CERTIFICATE OF APPROPRIATENESS

Property: 2805 Florence, lot 1A, 2B, & 9, block 11, Woodland Heights Subdivision. The property includes a 996 SF one-story single-family residence on a 7,797 square foot (80' x 100') interior lot.

Proposal: Alteration – Addition. The applicant is proposing to construct a two-story addition at the rear of the lot. The addition to the main house will be 427 SF and 632 SF for the garage.

FRONT EAST ELEVATION

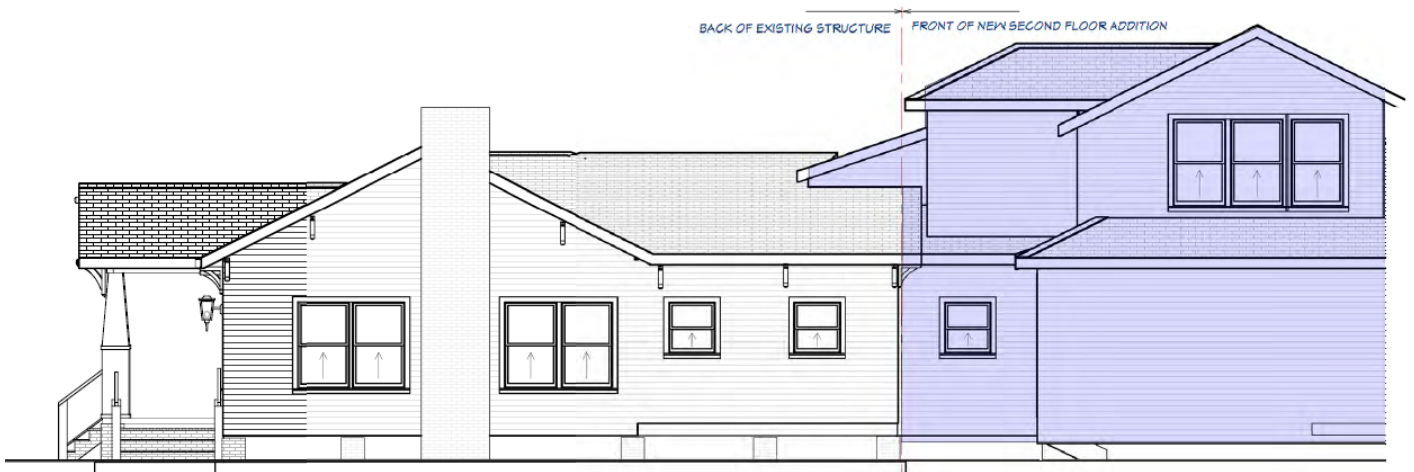
Recommendation: Approval with conditions: that the proposed craftsman style columns match the context area columns and are slimmer.
